9210100 PORTLAND CEMENT AND BLENDED CEMENT
INTERNAL/INDUSTRY REVIEW COMMENTS

Comments: (6-22-16, Internal)

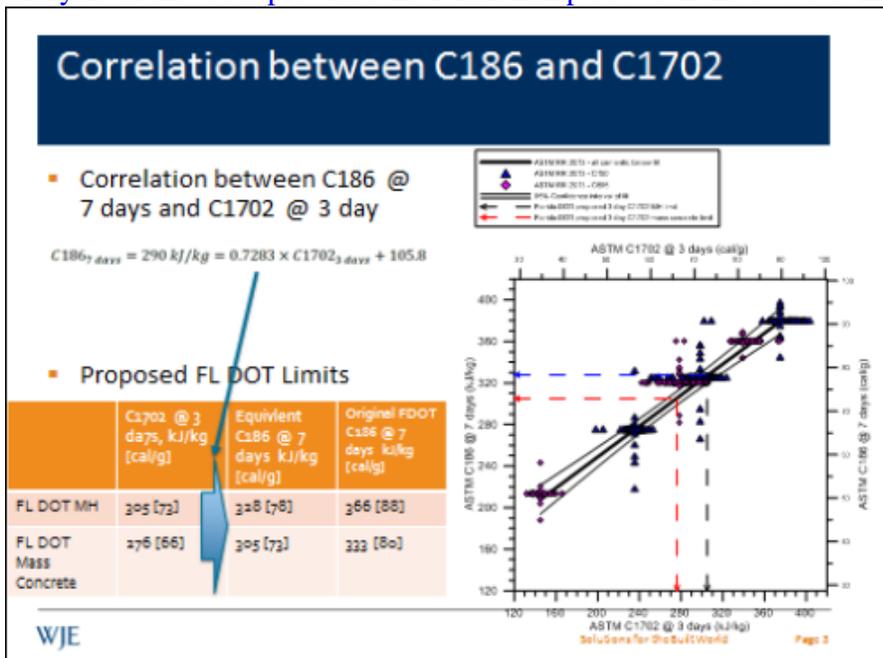
A primary concern with the initial FDOT 921-1.3 proposal is that 58% of cements supplied to Florida would not meet the proposed heat of hydration limit (73 cal/g) for cements used in structural concrete applications and 83% of cements would not meet the proposed limit for heat of hydration (66 cal/g) for cements used in mass concrete applications, as noted in the figure below:

The ASTM C01.26 subcommittee chairman has prepared a graph presenting data from round robin testing showing the relationship between 7-day C186 vs 3-day C1702 values. Regression analysis of that data provides the relationship between the two test methods in the table above.

Response: Changes made.
